I made the requested change at line 182: ‘evaluated’ to ‘evaluate’

Please note I found one additional error in supplementary figure 2. This figure was originally used to provide evidence for two statements in the main text regarding the performance of GLDAS v2.1. There is still analogous evidence for the original statement in a figure from the main document (copied below). I’ve therefore altered two sentences that originally referred to the supplementary figure to refer to the main text figure instead.

Figure 5 (as before, now used to justify statements above)

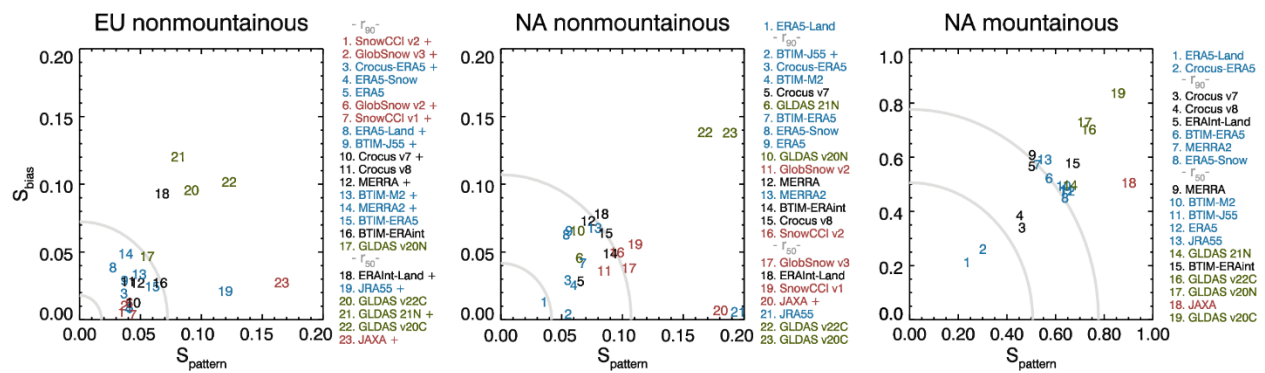
*“All four GLDAS products perform very poorly when evaluated hemispherically (Fig. 5) due in part to large biases (Figs. 2 and 4). However, GLDAS v2.1, which uses different precipitation forcing than the other three versions, performs better when evaluated regionally over the continental United States (Fig. S2), especially in mountainous terrain. Thus, while it is tempting to extrapolate regional performance, this product provides a good counter-example where doing is particularly detrimental.”*

*“GLDAS v2.1 provides a specific example where its performance over the continental US does not reflect its much poorer performance outside that region.”*

“In general, the GLDAS products perform poorly when evaluated hemispherically (Fig. 5) due in part to large biases (Figs. 2 and 4). However, GLDAS v2.1, which uses different precipitation forcing than the other three versions, performs better when evaluated over nonmountainous North America (Fig. 5). Thus, while it is tempting to extrapolate regional performance, this product provides a good counter-example where doing is particularly detrimental. “

“GLDAS v2.1 provides a specific example where its performance over nonmountainous North America does not reflect its much poorer performance outside that region.”
